**Proposal #43: 7120-01-74**  
**Durand – Eau Claire**  
**Rock Creek Bridge B-17-0226**  
**STH 85**  
**Dunn County**

This is Addendum No. 02, which provides for the following:

**ADDENDUM NO. 02**

Addendum No. 02  
 ID 7120-01-74  
 Revised Sheet 16  
 April 27, 2020

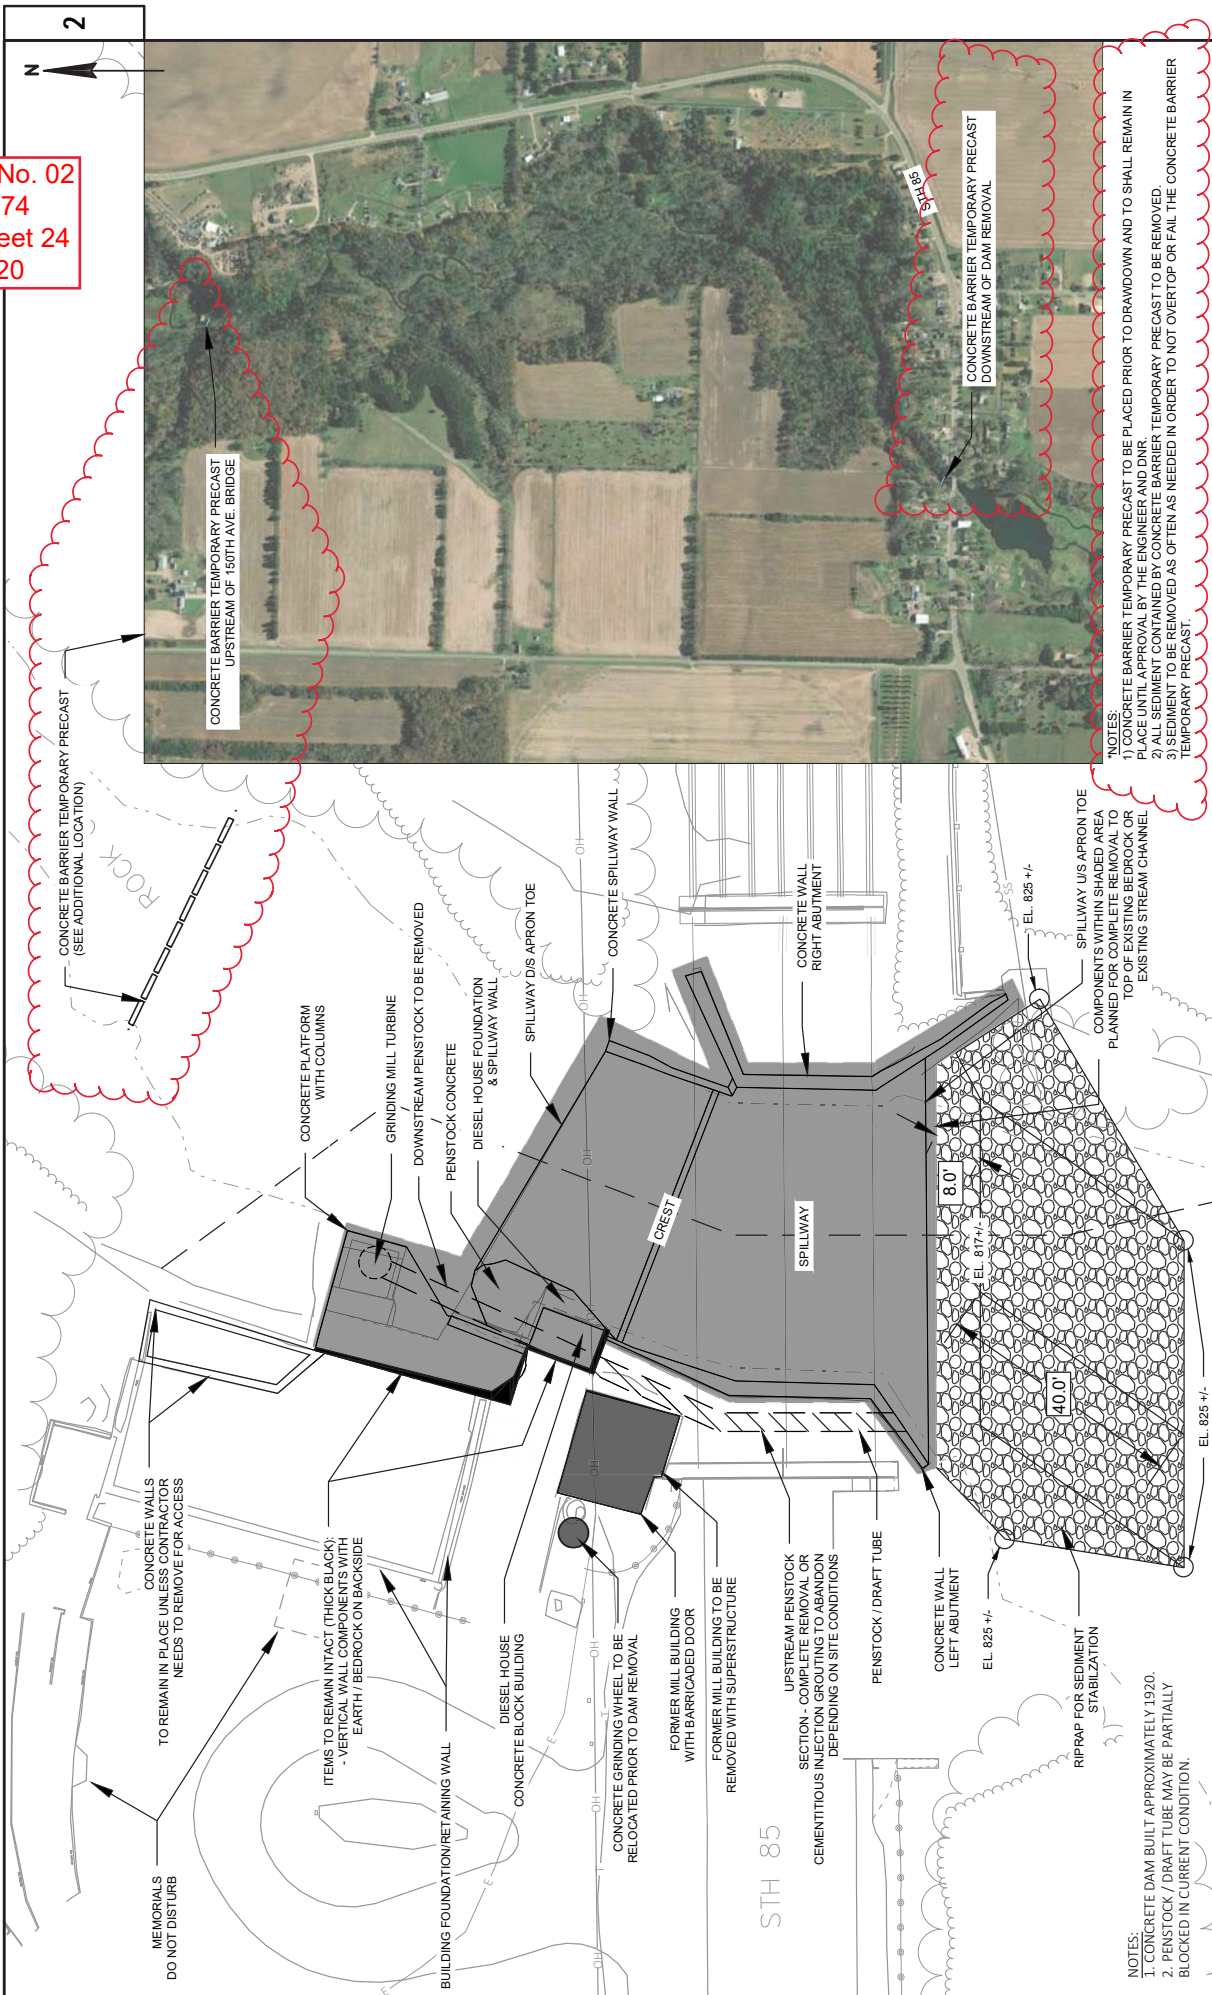
<b>Revised Plan Sheets</b>	
<b>Plan Sheet</b>	<b>Plan Sheet Title (brief description of changes to sheet)</b>
9	Erosion Control Sheet – Replaced Turbidity Barrier with Concrete Barrier Temporary Precast
16	Dam Details – Plan View – Replaced Turbidity Barrier with Concrete Barrier Temporary Precast
21	Dam Removal – Access, Staging, Phasing, & Dewatering Plan – replaced Turbidity Barrier with Concrete Barrier Temporary Precast
24	Dam Removal Areas – Plan View – replaced Turbidity Barrier with Concrete Barrier Temporary Precast
31	Miscellaneous Quantity sheet – deleted Turbidity Barrier. Added Concrete Barrier Temporary Precast items.
